Joseph M. Farley Nuclear Plant - Unit 2
Response to NRC Questions - Reactor Vessel Surveillance
Capsule Report and Associated Technical Specification Change Request

NRC Staff Request for Information
Heatup/Cooldown Curves
Joseph M. Farley Nuclear Plant Unit 2

FIGURE 1 SHELL-TO-FLANGE WELD JOINT

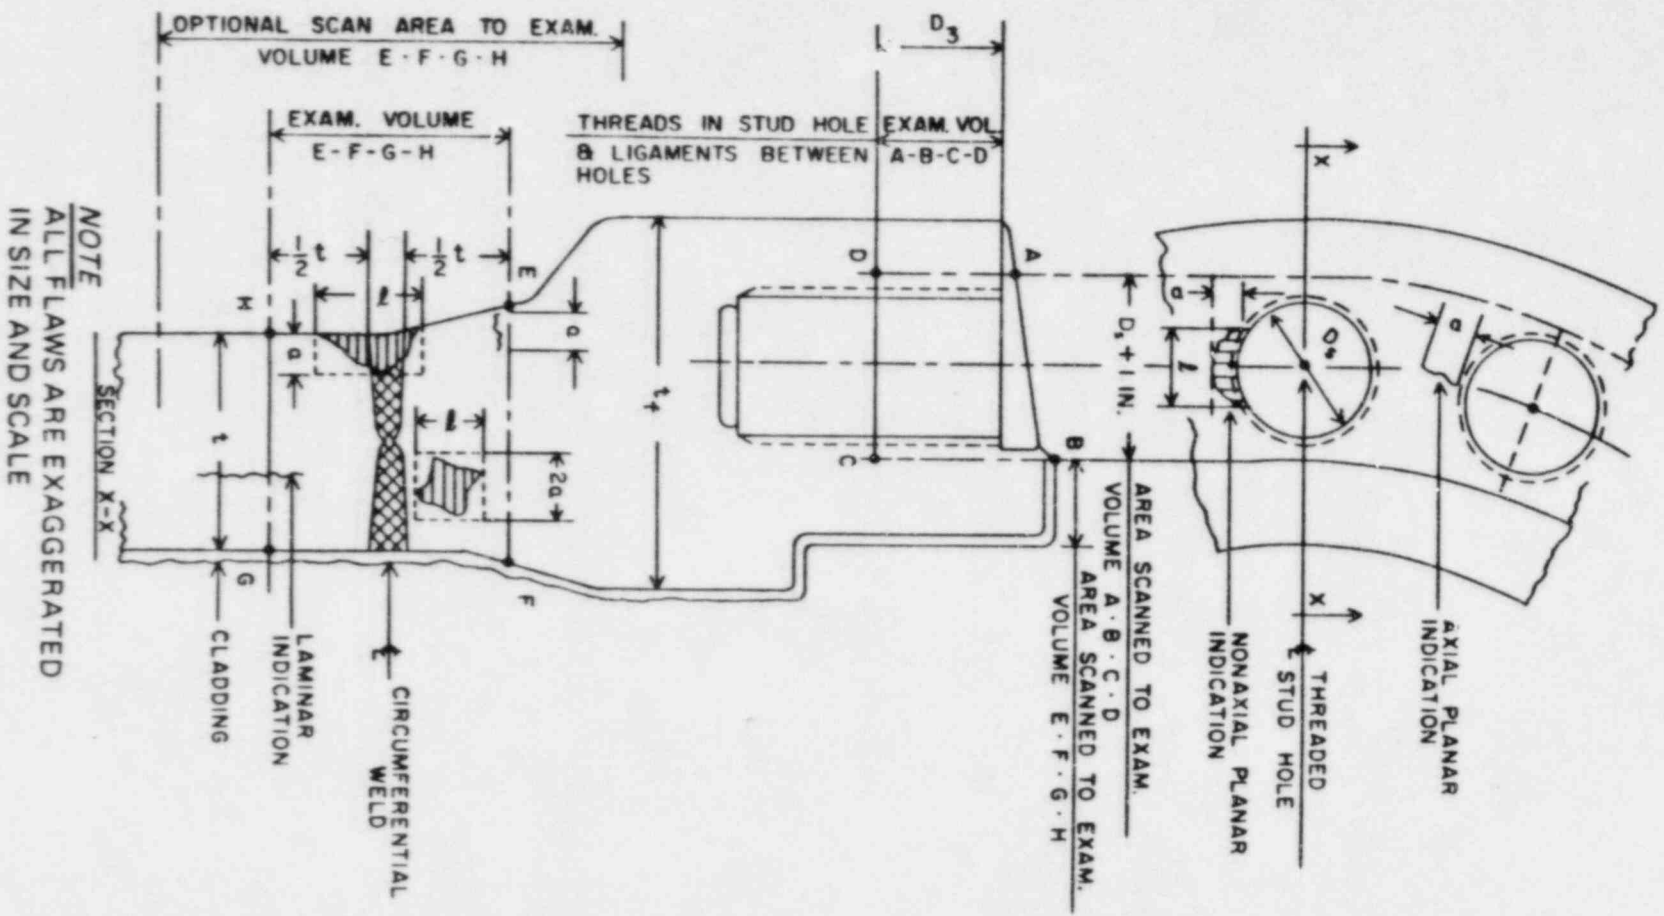
- f) Indicate the nondestructive examination methods that will be used during inservice examination to determine that the critical flaw size, which was used in determining the maximum applied stress intensity factors, is not within the flange to head and flange to shell junctions.

the boundaries for volumetric examination to include the weld and adjacent base material for a distance equal to one-half the weld thickness on both sides of the weld. The areas to be inspected are graphically represented in the Attached Figures 1 and 2.

Volumetric coverage of the reactor vessel flange-to-upper shell weld and specified adjacent base material is accomplished by two ultrasonic scan routines. Coverage from the flange side of the weld involves use of angled longitudinal waves from the flange seal surface. Beam angles are selected based on their ability to provide coverage of the weld and specified adjacent base material to the extent practical and provide near normal incidence to the plane of the weld. Refracted beam angles in the range 0° to 16° are typically used for these examinations. Examinations from the shell side of the weld involve 0° , 45° , and 60° refracted angle beam coverage from the vessel inside diameter surface. Angle beam scanning is performed in two directions parallel to the weld and perpendicular to the weld from the shell side. Access for the shell side examinations is limited to the Ten Year ISI outage when the core barrel is removed from the reactor vessel.
